COUNCIL ACTION FORM

REQUEST: MAJOR SITE DEVELOPMENT PLAN FOR 2121 COTTONWOOD ROAD

Attachment B: Major Site Development Plan (Landscaping)

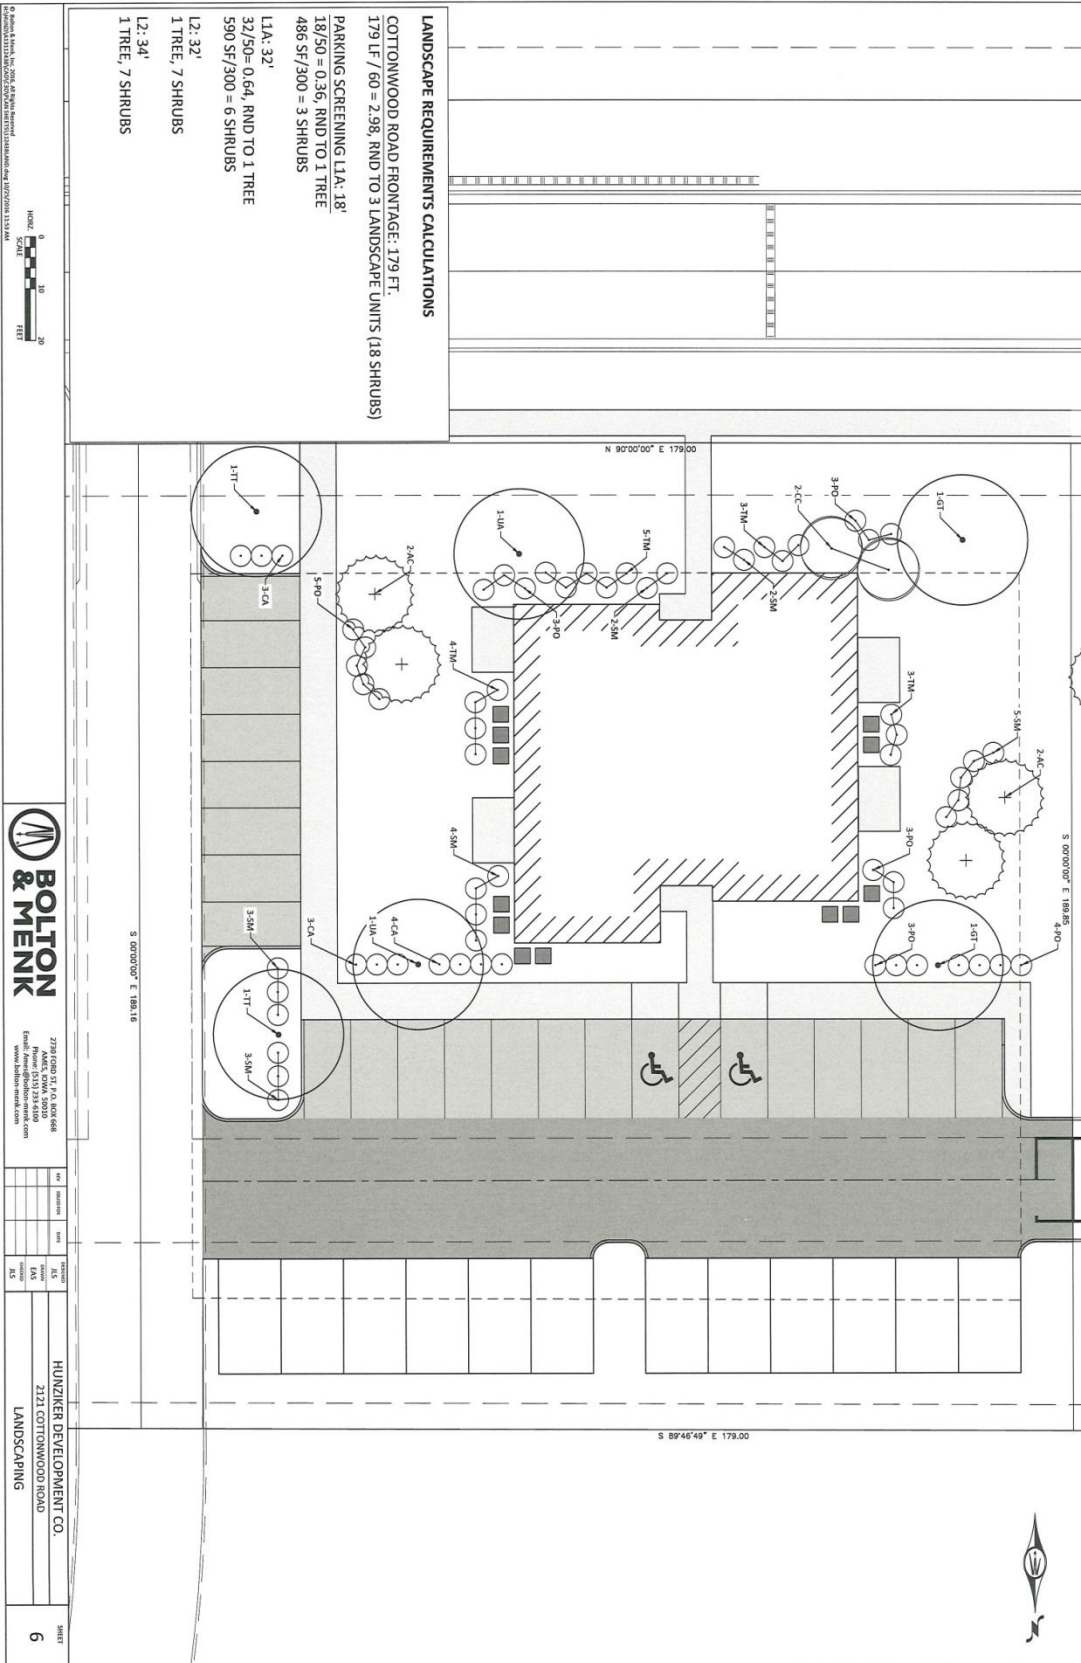
The Landscape Plan shows screening for mechanical units along the east and west sides of the building that meet site plan standards, provided the shrubs used for screening are a minimum of six inches higher than the mechanical units, at the time of planting. A condition is included in the report as a reminder of the need to comply with screening at the time of planting compared to growing into a screen over time.

The trash receptacles are screened with 1" by 6" vertical cedar wood alternating slats to a height of six feet. The site plan does not include gates for the enclosure. Gates are necessary to meet screening requirements in Section 29.408(3) of the Municipal Code, which requires that garbage collection areas be screened from all public rights-of-way and from adjacent properties.

The general development standards of the zoning ordinance have been met for the screening of parking areas. Gates are needed on the trash enclosure to comply with the zoning ordinance standards for screening garbage collection areas. The enclosure standard requires full fenced screening with a gate to ensure the compliance with the standards. In this plan the design has a large opening for rollout of the dumpster with no gate to obscure or secure the dumpster. The apartment building provides a high degree of separation and screening of the parking and garages in the rear yard from adjoining views, and as viewed from Cottonwood Road.

- D. Prior to consideration by the City Council, gates must be added to the Major Site Development Plan, for screening of the garbage collection areas, in order to meet the requirements of Section 29.408(3) of the *Municipal Code*.

- E. Prior to occupancy of the apartment building at 2121 Cottonwood Road, shrubs used as screening for mechanical units must be installed to meet zoning standards at a minimum height that is six inches higher (at the time of planting) than the mechanical equipment the shrubs are screening.

- C. The landscape plan shall include revisions necessary to specify plantings appropriate in size equal to the height of the mechanical equipment to ensure the compliance with the zoning ordinance screening requirements.
